## Bulletin

**Application:** ZF 4HP22E 1984-88

**Subject:** New “Combo” Valve Body Gasket

#12112

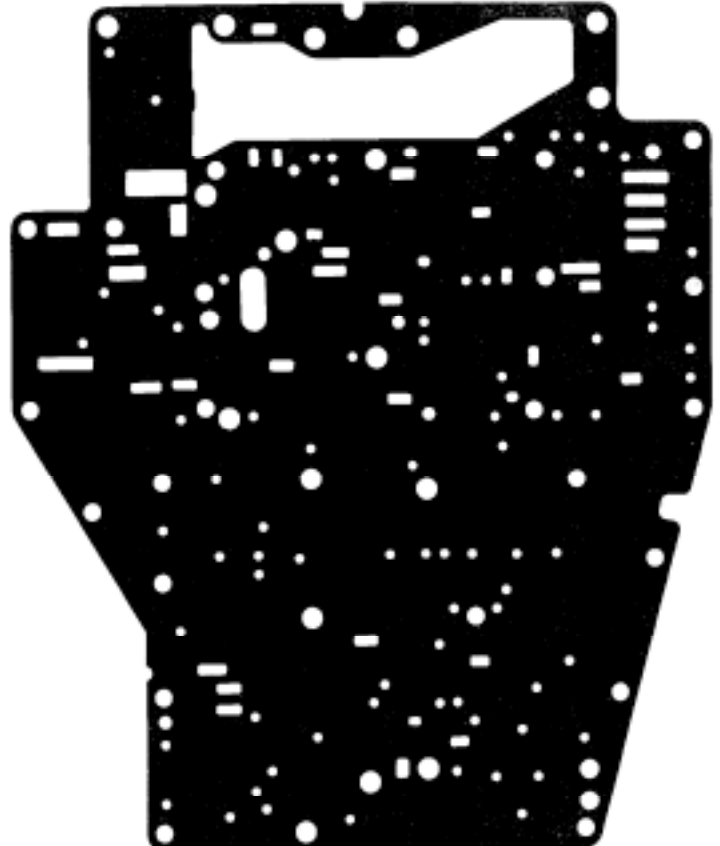
We are now offering a new “combo” gasket for the 1984-88 ZF4HP22E. The new gasket fits all models and vehicle applications of this unit. TransTec #12112 is now included in all TransTec kits with a date code of K02 and later, and replaces #12601 in all ZF4HP22/24 overhaul kits.

Arrows indicate holes that have been added or changed:

TransTec #12112 replaces #12601 and OEM numbers 1043-326-161 & 1043-326-232.
